Re: FortisBC Energy Inc. (FEI)

Application for a Certificate of Public Convenience and Necessity (CPCN) for the Tilbury Liquefied Natural Gas (LNG) Storage Expansion (TLSE) Project (Application)

Response to the Commercial Energy Consumers Association of British Columbia (CEC) Information Request (IR) No. 1

Figure 1-2: Illustrative Timeline of T-South Supply Emergency and Available Resources

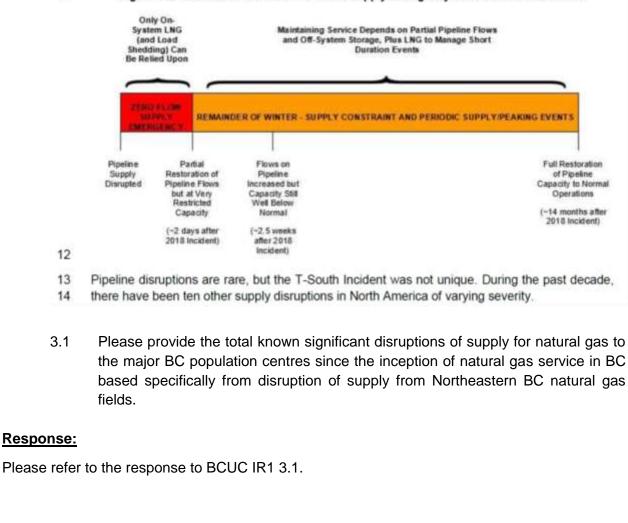
40	D	
11		
10		on account of the event.
9		the last 20 years and note any supply disruptions and the estimated revenue loss
8	3.3	Please provide the FEI natural gas revenues and number of customers for each of
7		
5 6

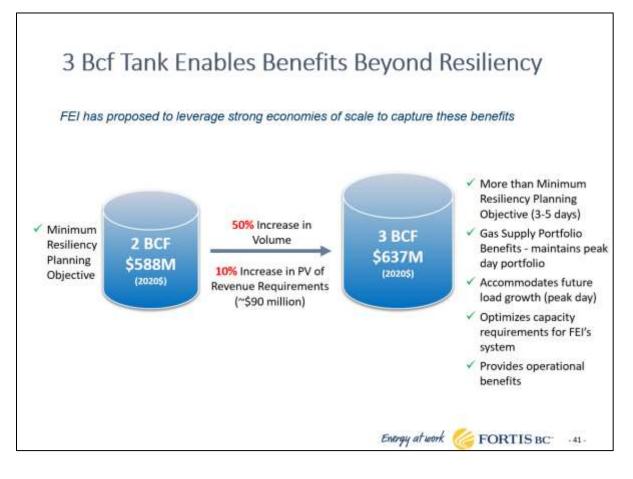
9.1 Please describe and value the ancillary benefits of the additional 1 Bcf in the FEI proposal as compared to the \$50 million marginal capital cost addition.

- 9 B-4, reproduced below for convenience). The value of the gas supply benefits is discussed in the
- 10 response to BCUC IR1 46.2. As discussed in that response, the value of the gas supply benefits
- 11 alone outweigh the incremental costs of the additional 1 Bcf such that customers are better off
- 12 with the 3 Bcf tank than a 2 Bcf tank. The other ancillary benefits associated with the 1 Bcf storage
- 13 as defined in the Application cannot have a value attributed to them at this time.
